Memo: M015-A

Ancoats Gardens, Rochdale Road, Manchester

Proposed acoustic testing schedule

Level 00 - Ground floor

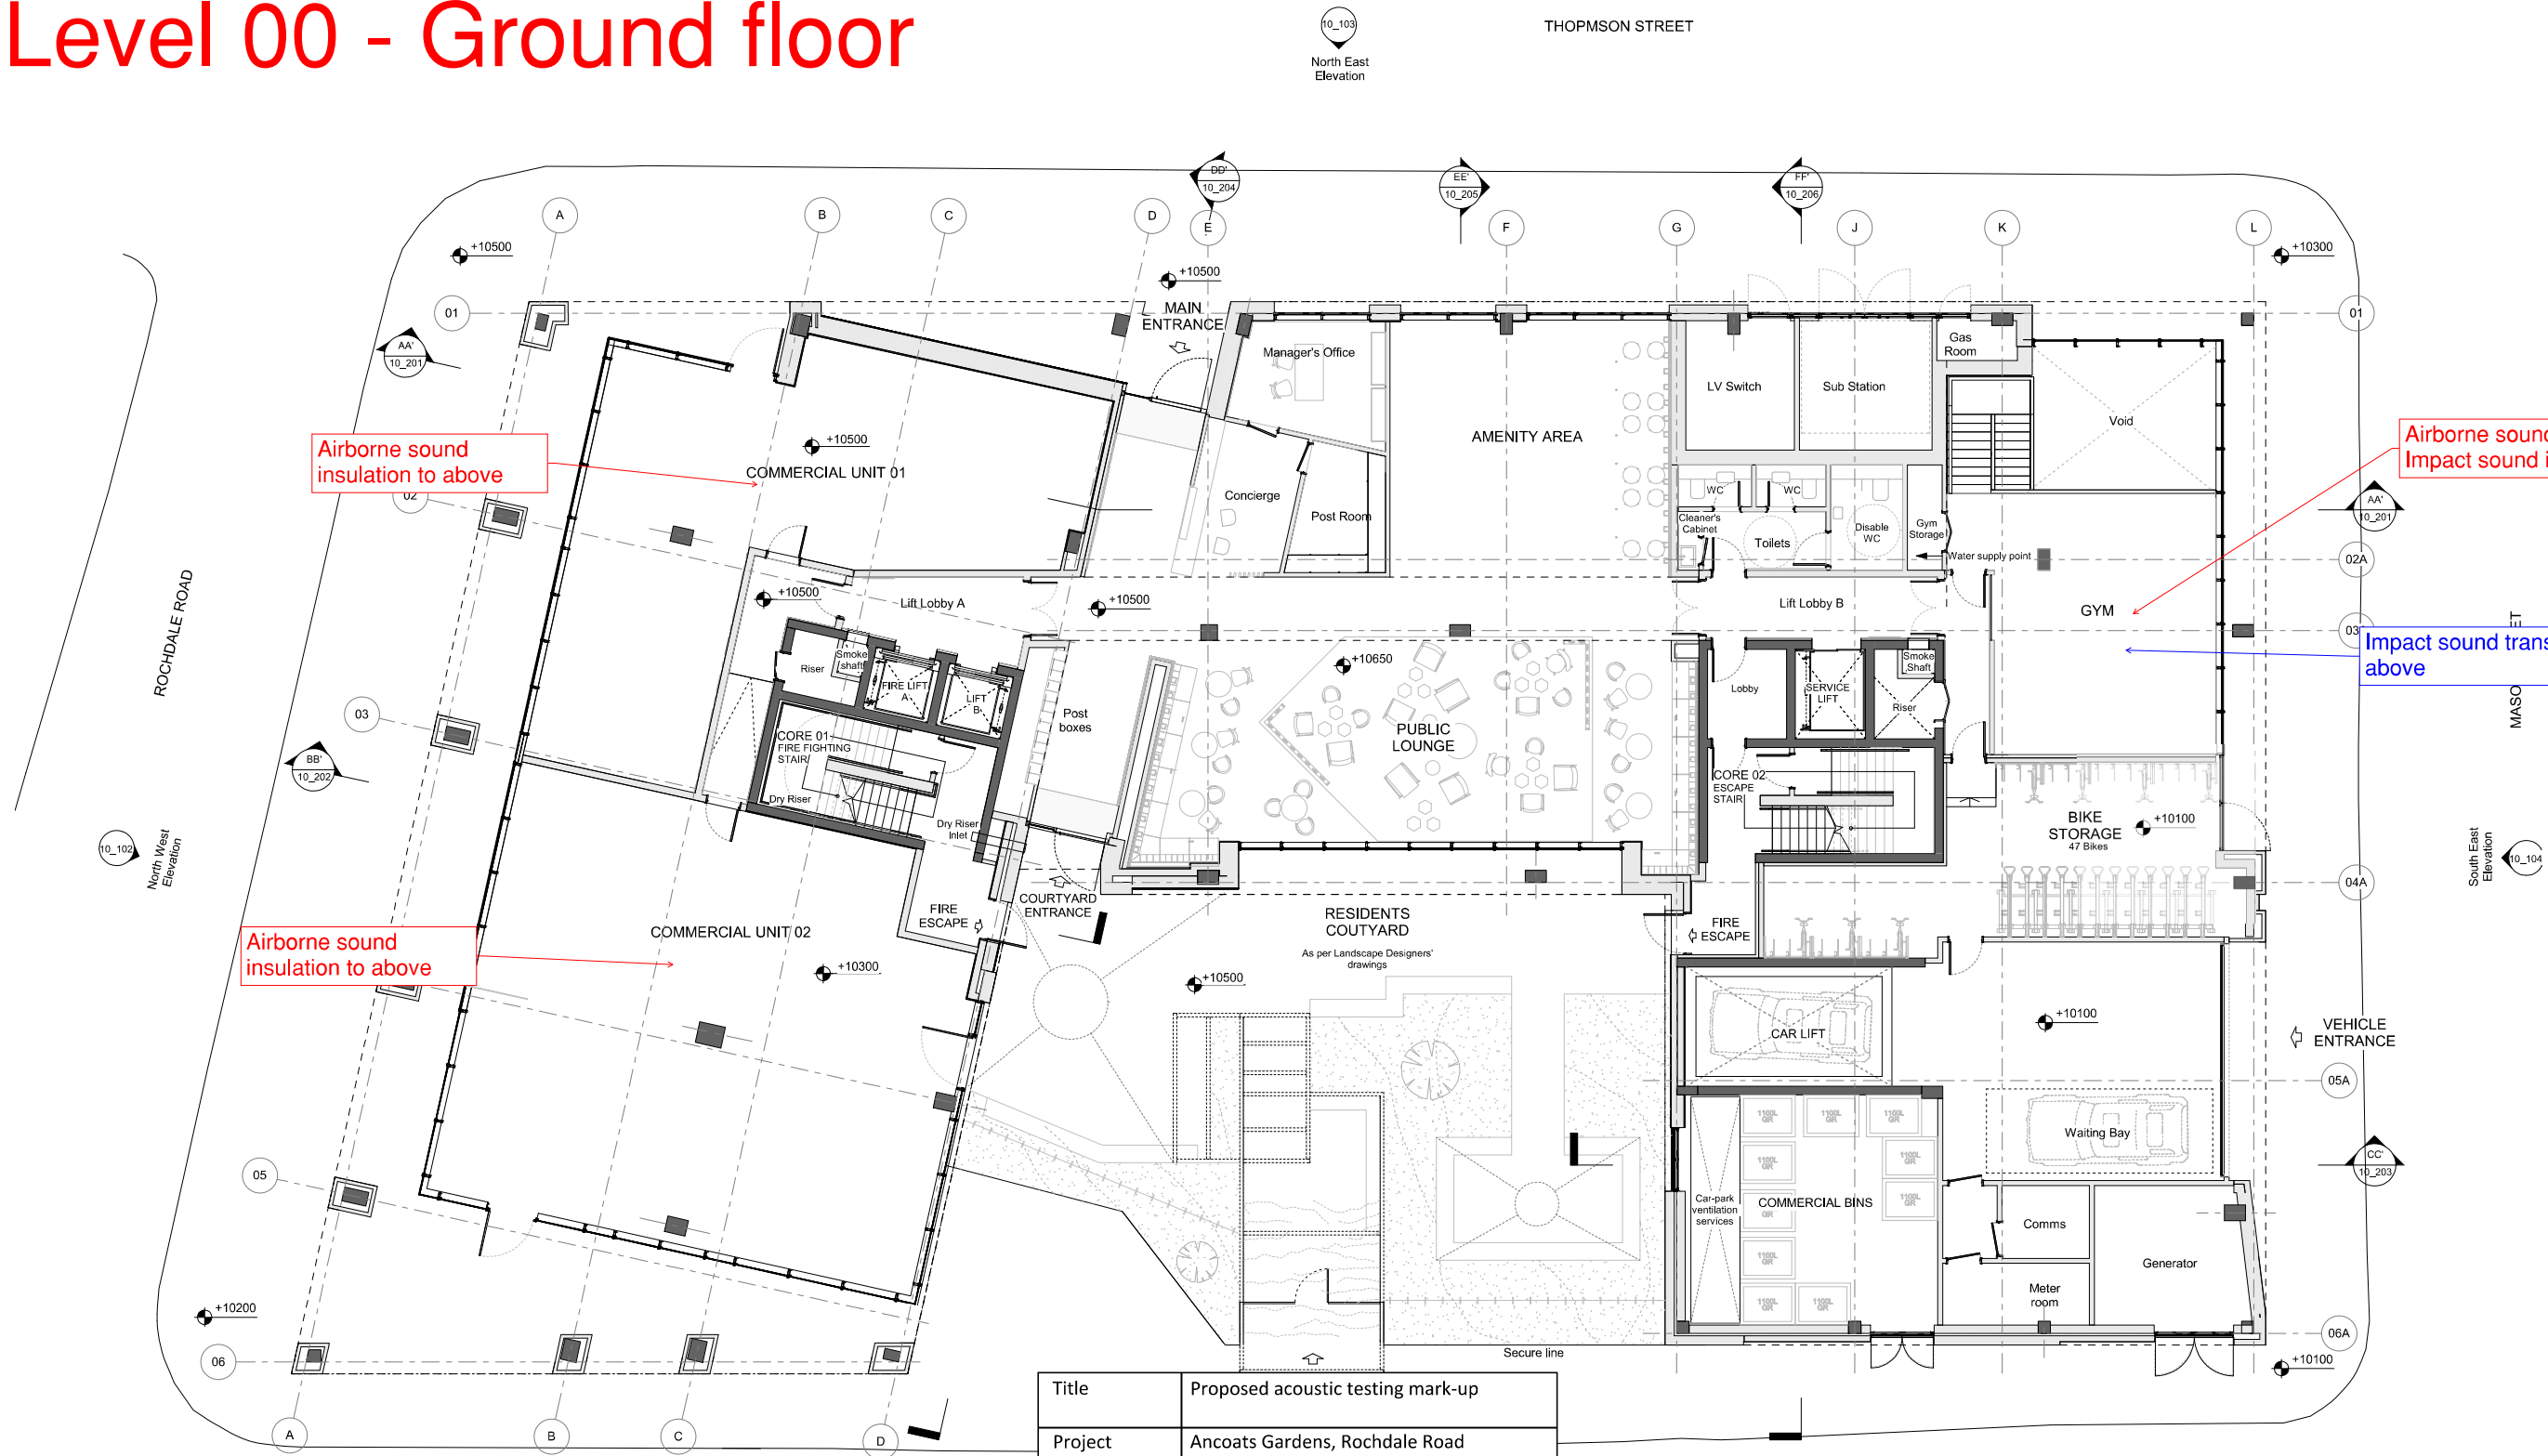
1 Proposed GA Plan - Level 00
1 : 100

Level 01

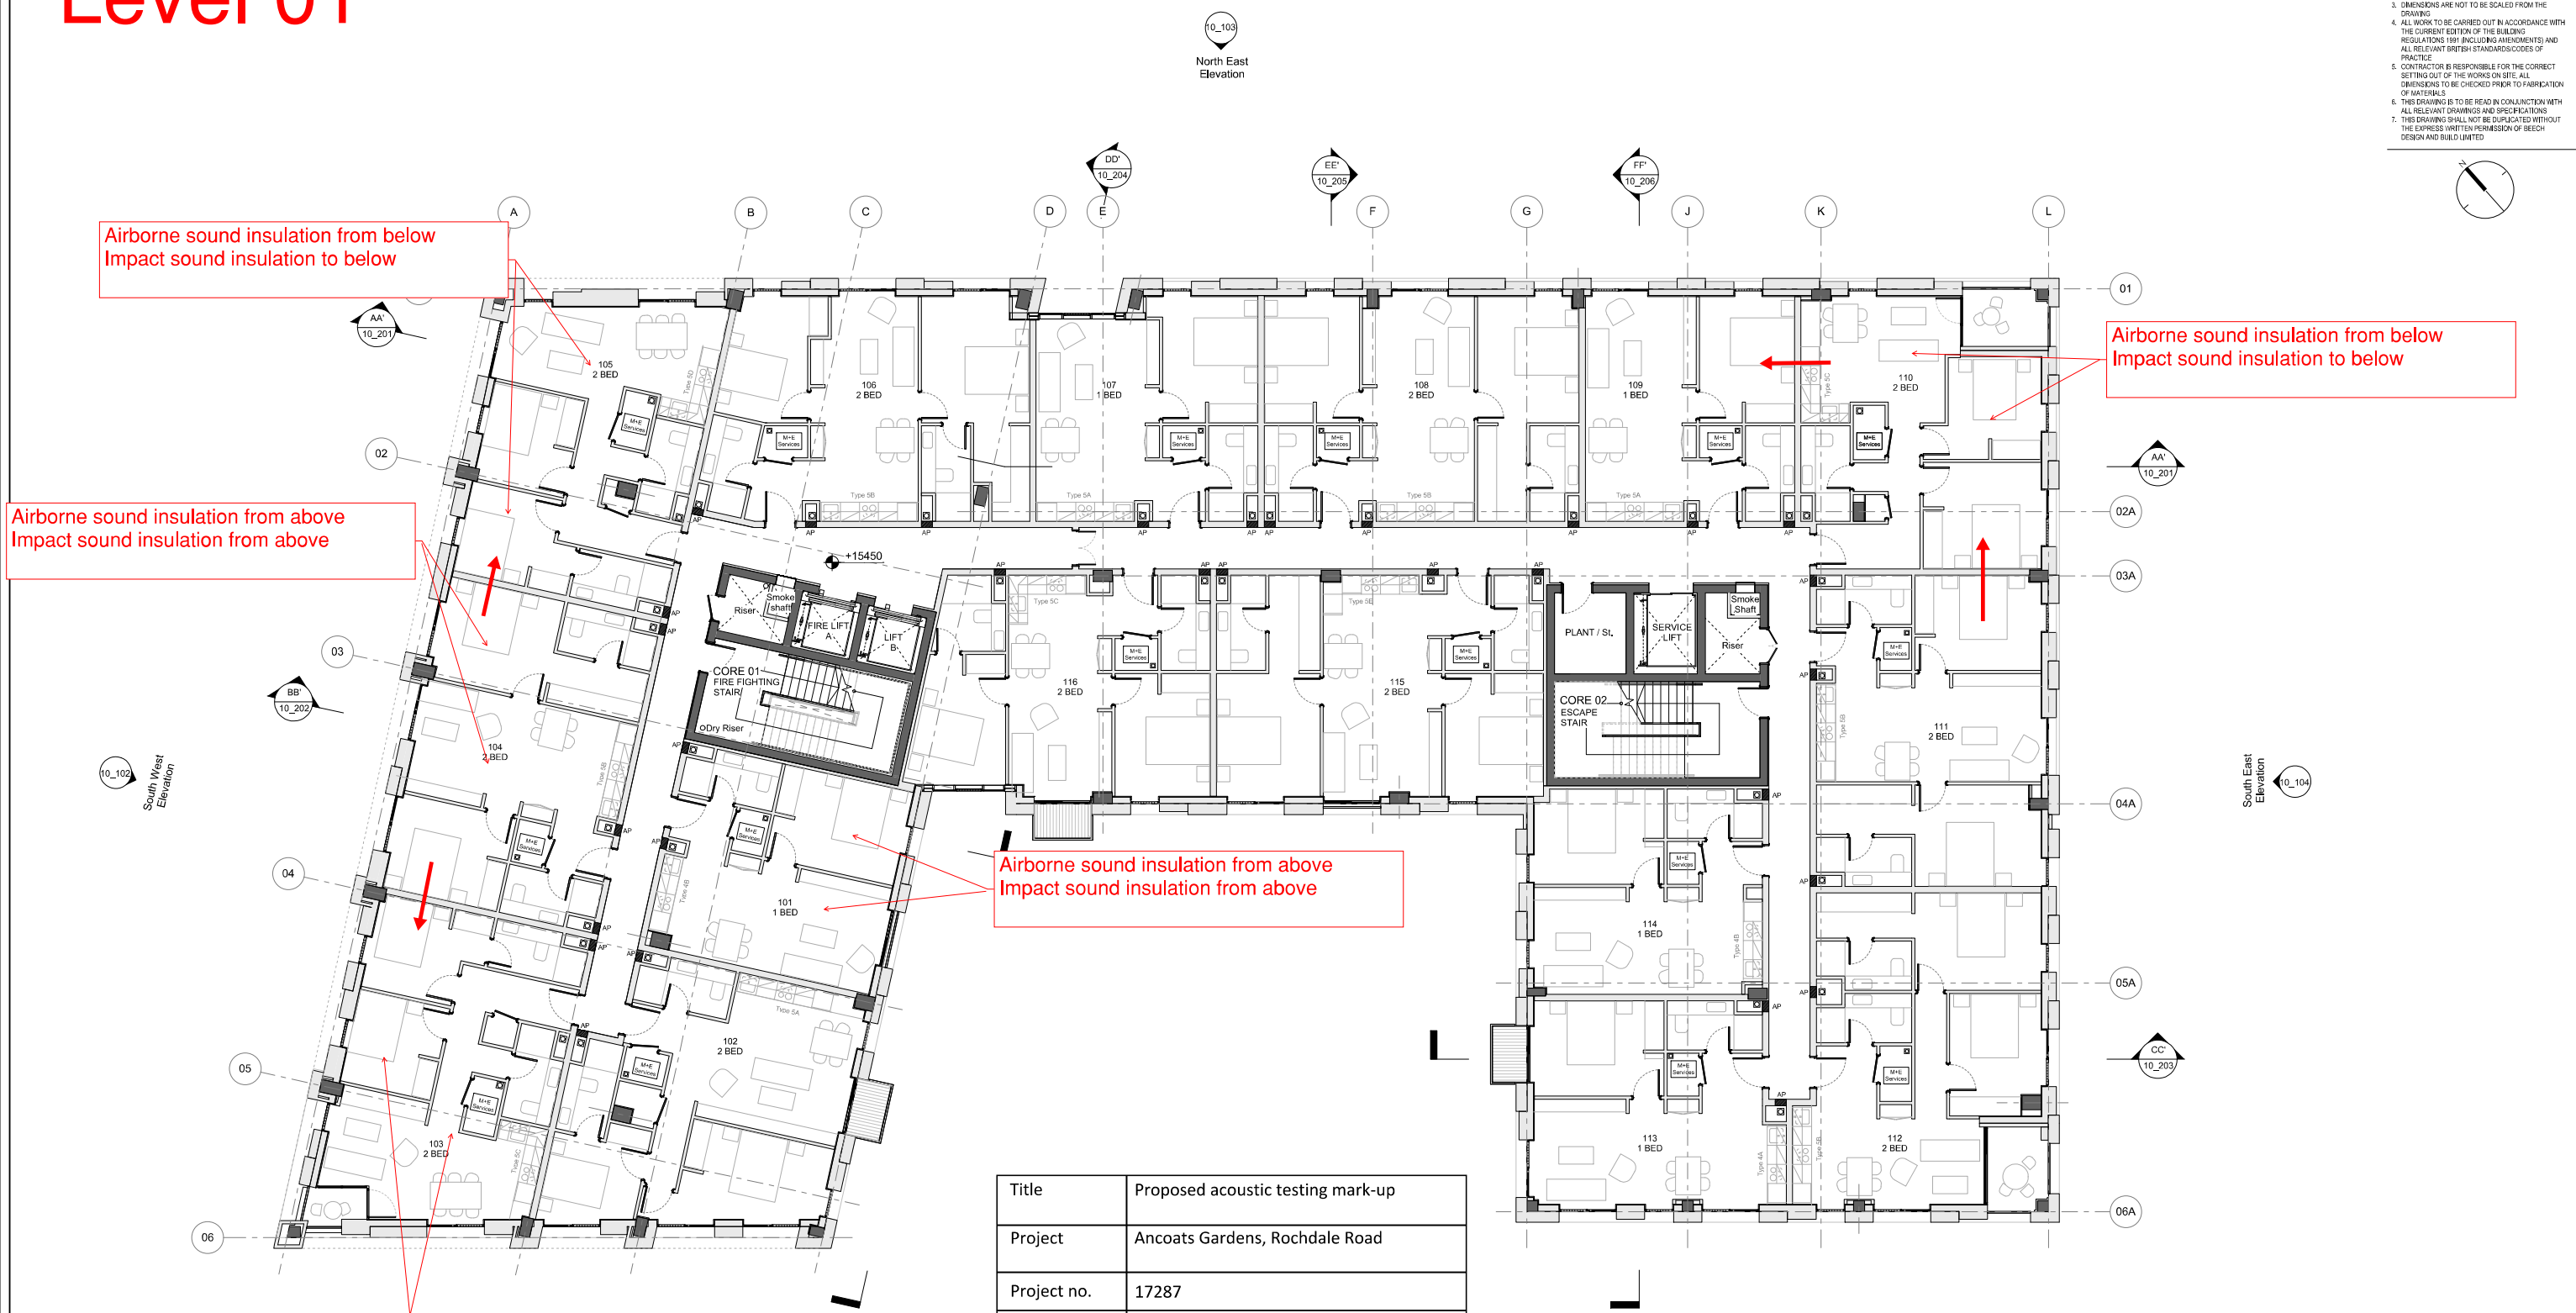
Title	Proposed acoustic testing mark-up
Project	Ancoats Gardens, Rochdale Road
Project no.	17287
Version	A
Marked-up by	Jose M. Gonzalez
Reviewed by	Matthew Robinson
Date	6 July 2022
Mark-up key	
 Test direction	
SANDY BROWN Consultants in Acoustics, Noise & Vibration

Level 03

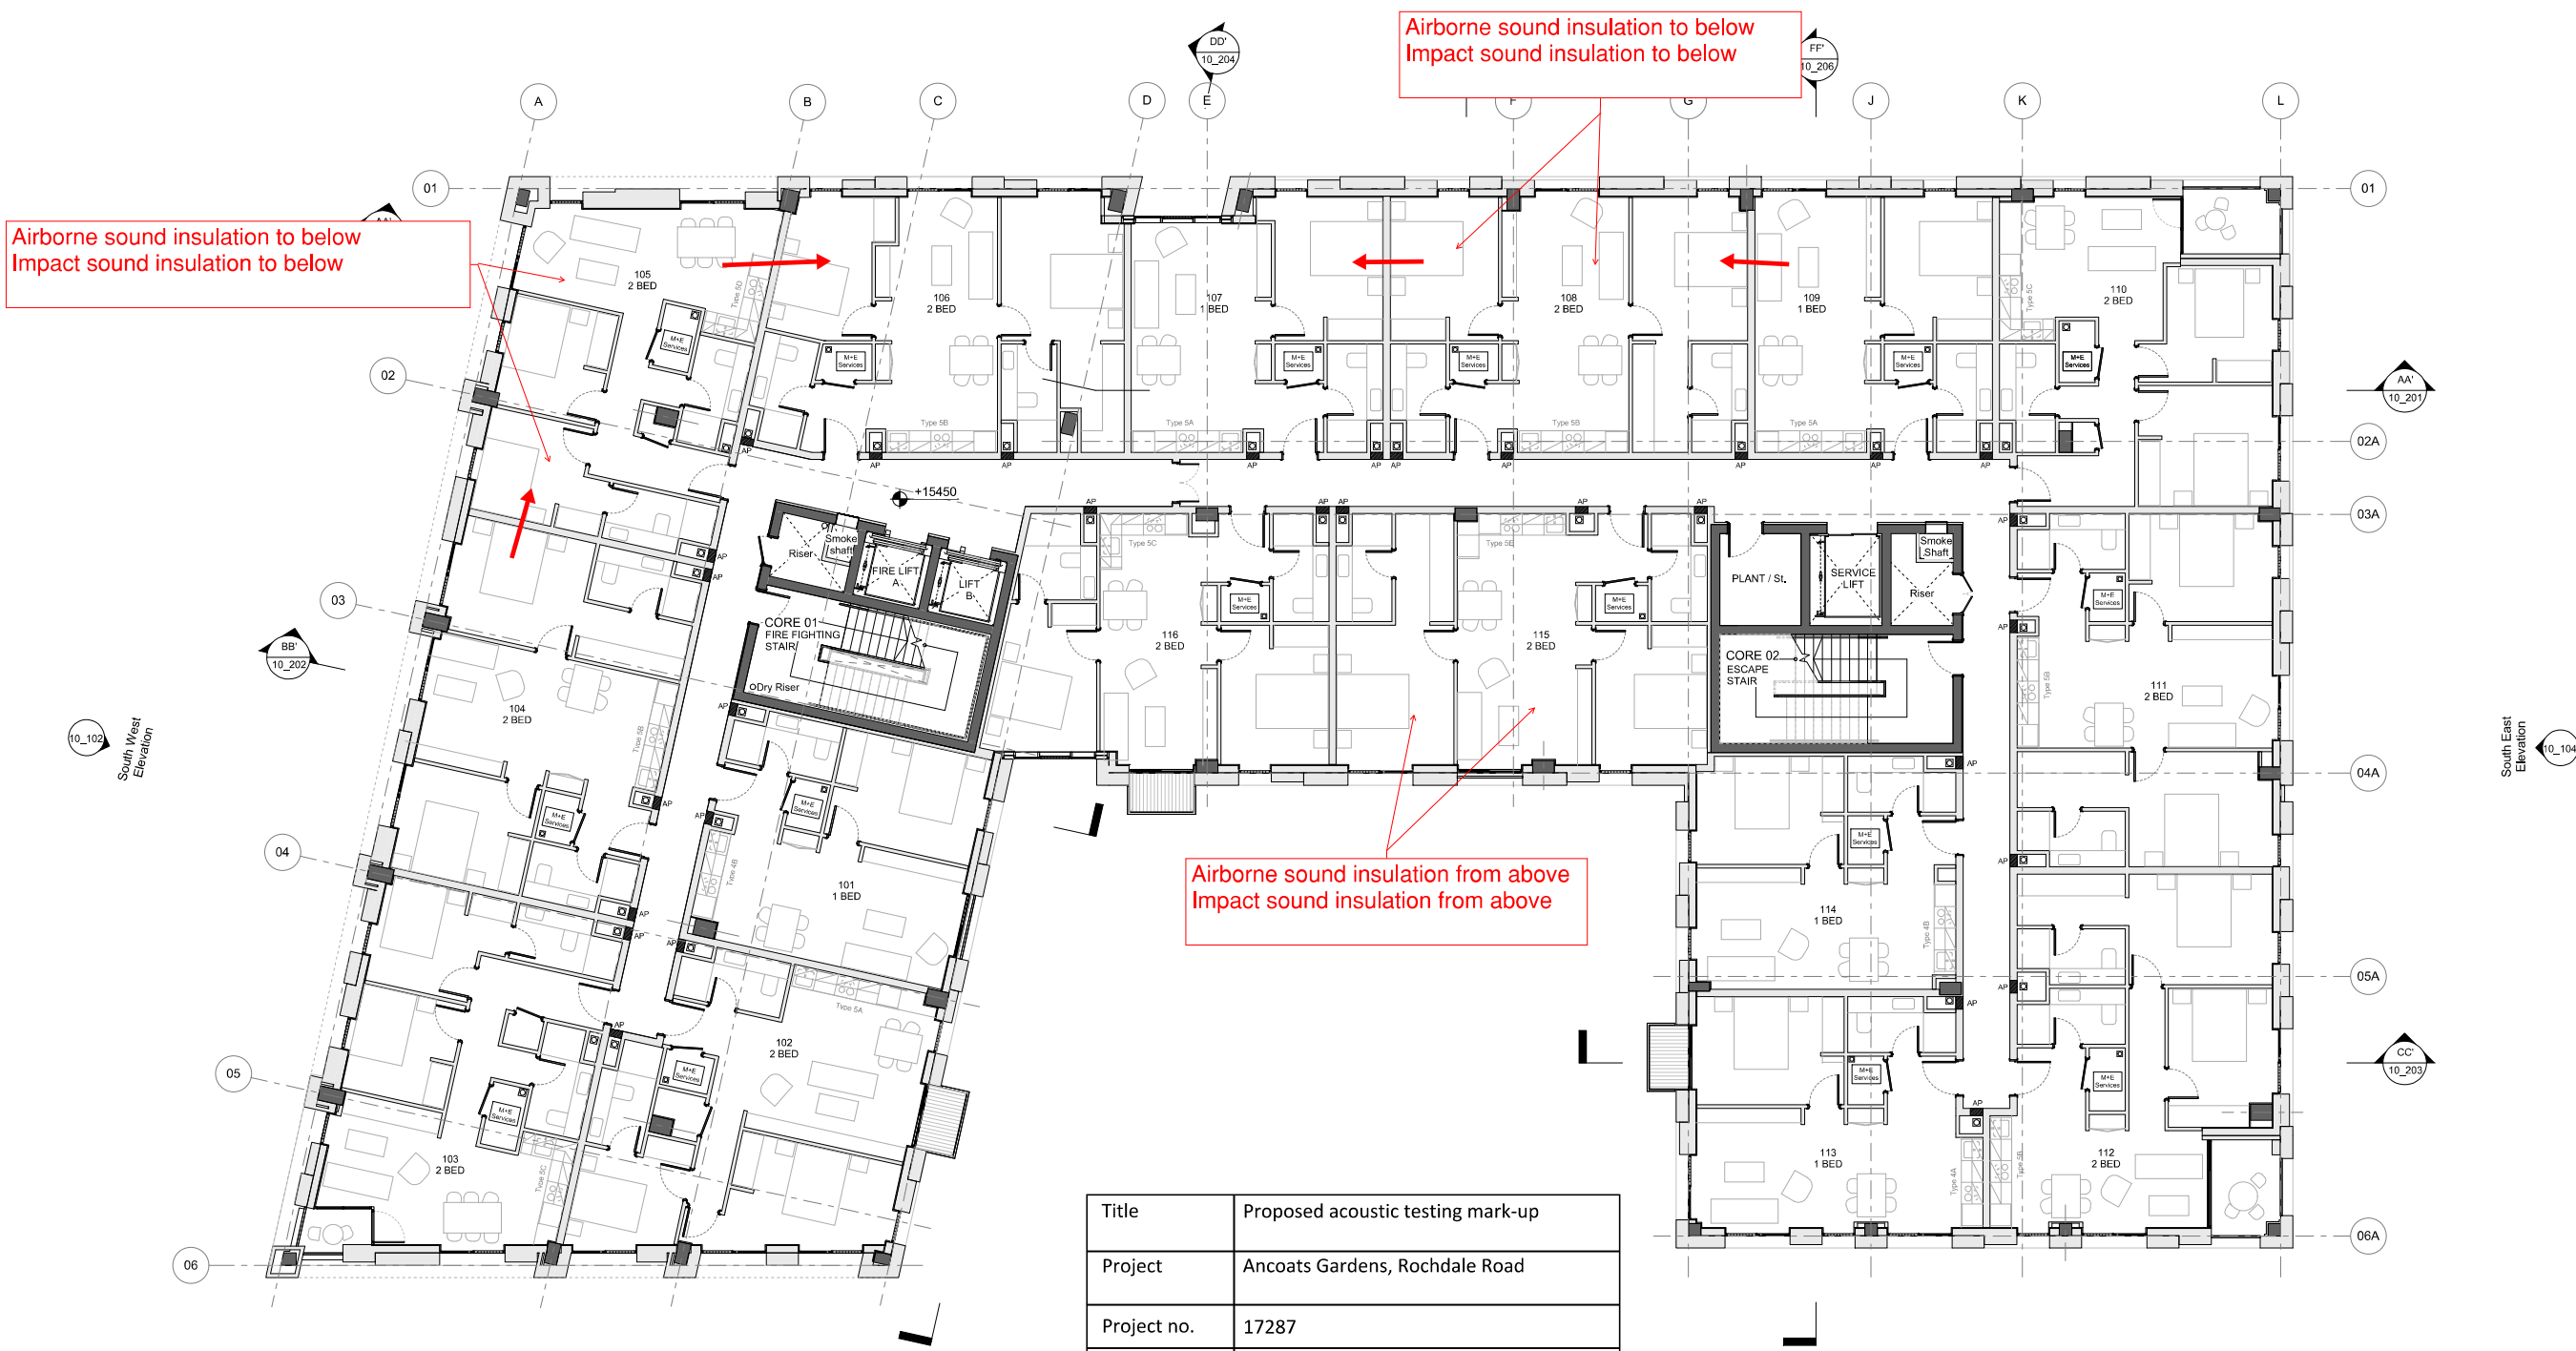
Airborne sound insulation from above
Impact sound insulation from above

Airborne sound insulation from above
Impact sound insulation from above

Airborne sound insulation to below
Impact sound insulation to below

Airborne sound insulation to below
Impact sound insulation to below
